2016SYE087 – 2-4 Locksley Street & 31-39 Sturt Road  
Cronulla

DA16/0994

## ASSESSMENT REPORT APPENDICES

**RE: RESPONSE TO REQUEST FOR INFORMATION TO DEVELOPMENT APPLICATION (DA) 16/0994 FOR DEVELOPMENT AT 31-39 STURT ROAD, AND 2-4 & 2A LOCKSLEY STREET, CRONULLA**

## ANNEXURE A: EXTRACT OF COUNCIL'S 23<sup>RD</sup> SEPTEMBER 2016 LETTER

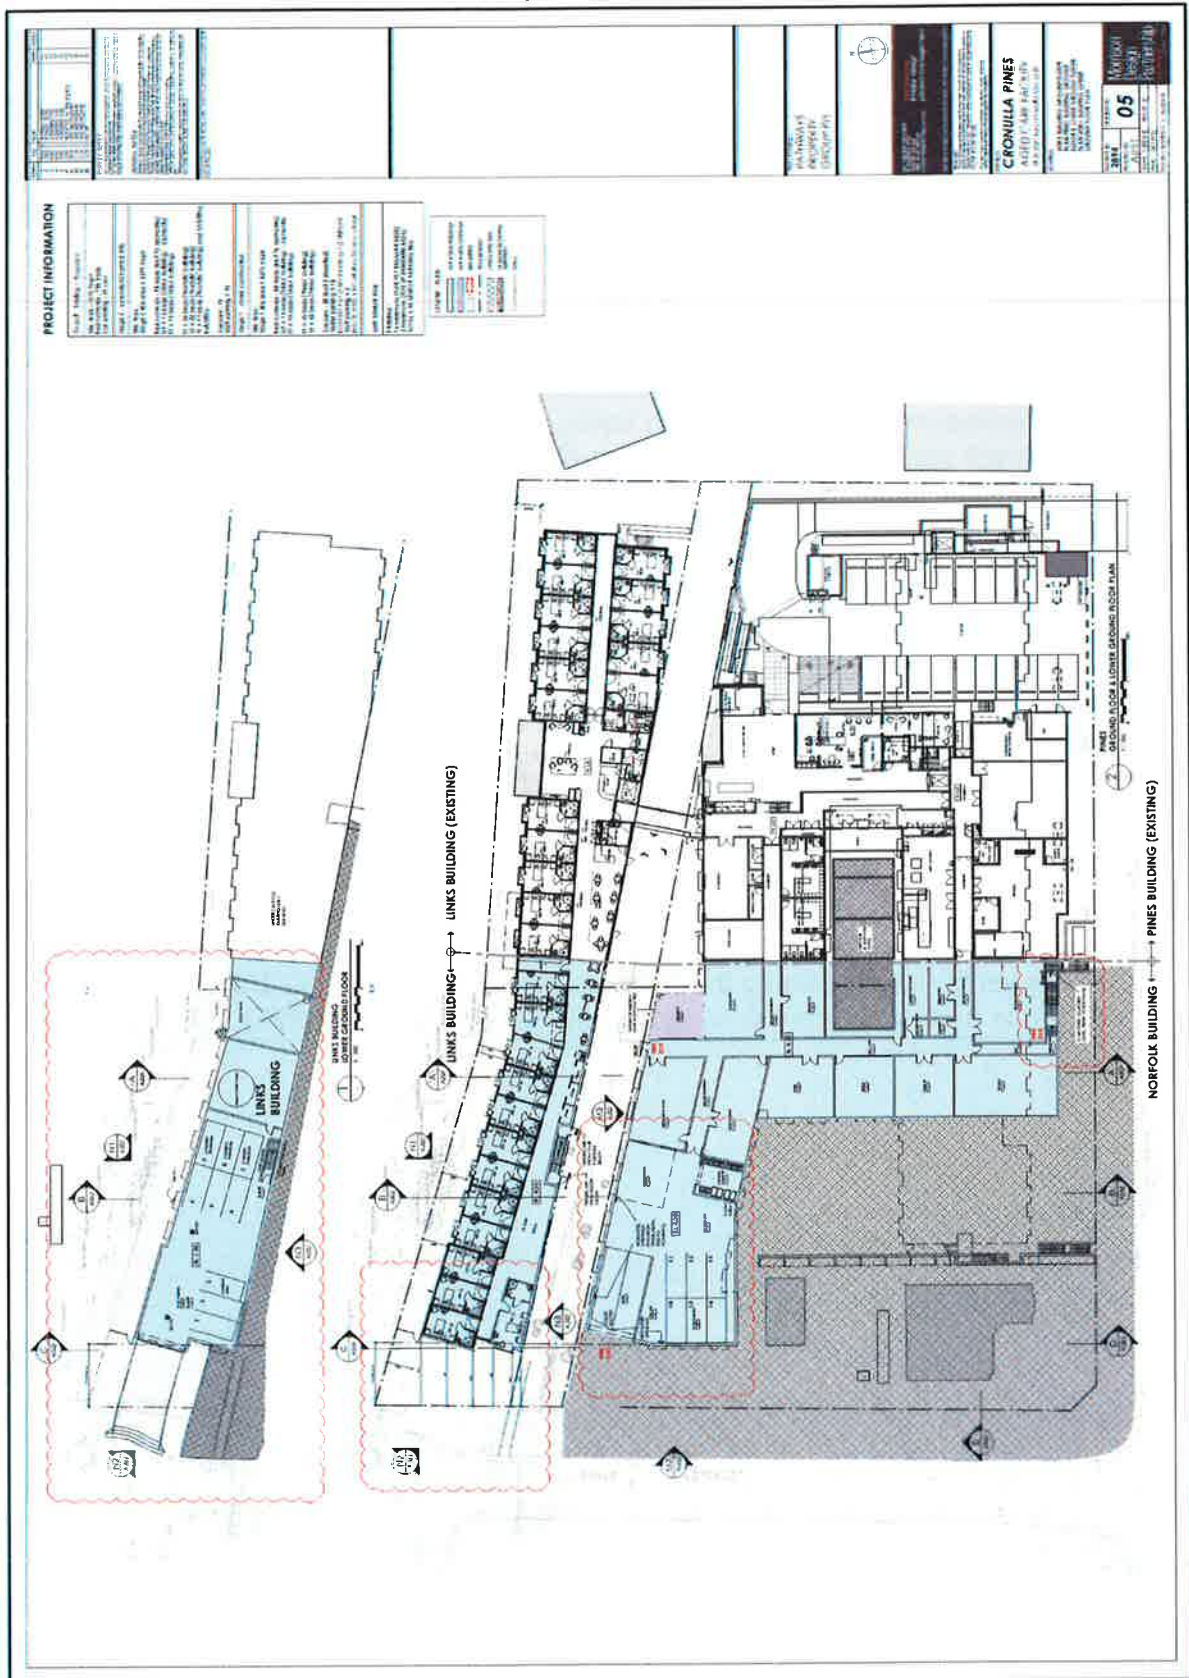
- iii) An amended traffic report must be submitted addressing the following:
  - The manoeuvring diagrams within traffic report must be updated to match the basement parking layout shown in the Architectural plans and the SRV must demonstrate forward entry / exit within the site using the proposed turning bay and without scraping the basement walls,

- Demonstrate an "SRV" can enter/exit the driveway within Locksley Street when vehicles are parked adjacent and opposite the proposed crossing,
  - Detail the headlight treatment required for the properties opposite both driveway accesses within Locksley Street,

- vi) No details have been provided on the orifice diameter. The applicants engineer must provide orifice details to be included onto the stormwater plans.

- vii) Carpark vents / louvres along the northern elevation of the Links Building are required to have a sill level at or above the PMF level of 2.1m AHD.

- i. Minimum headroom of 3.5m has been provided for the SRV loading and circulation areas.
- ii. Section 1 provided in **Annexure B** show compliant gradients for SRV access; that is a maximum grade of 15.4% with transitions of 8.3% are not exceeded.

- iii. Amended swept paths are provided in **Annexure C** for the revised parking and loading layout. The on-site manoeuvring facilitates forward entry and exit onto Locksley Street. It should be noted that the parking demand within Locksley Street is low and the probability of parked cars adjacent to the southern driveway is unlikely, however it would be beneficial that an 8.0m kerb length be signposted as "No Stopping" to ensure manoeuvring to and from the driveway can be achieved. The revised driveway location for the SRV is unlikely to result in headlight issues, as opposite the driveway is a retaining wall and vegetation, both of which will mitigate any concerns relating to headlights.

- iv. This is to be addressed by others.
- v. Detailed civil plans have been prepared by AT&L.
- vi. This is to be addressed by others.
- vii. This is to be addressed by others.
